<b>Notice of Allowability</b>	<b>Application No.</b>	<b>Applicant(s)</b>	
	10/731,770	AHRNKIEL ET AL.	
	<b>Examiner</b>	<b>Art Unit</b>	
	Sara Addisu	3722

### **EXAMINER'S AMENDMENT**

FIG. 3

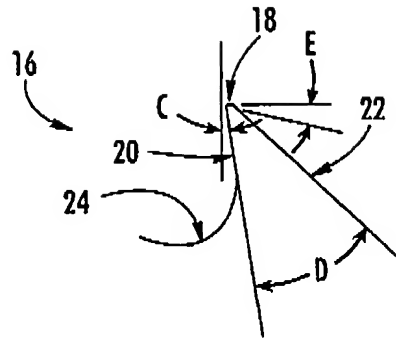
The following changes to the drawings have been approved by the examiner and agreed upon by applicant: figure 3 of the Instant Application did not show the "flat" (18) extending horizontally. Mr. Kirk faxed a proposed replacement sheet for figure 3 (attached with this Office Action). The official copy of the replacement sheet per the agreed upon proposal drawing (changes) will be filed by the Applicant. In order to avoid abandonment of the application, applicant must make these above agreed upon drawing changes.
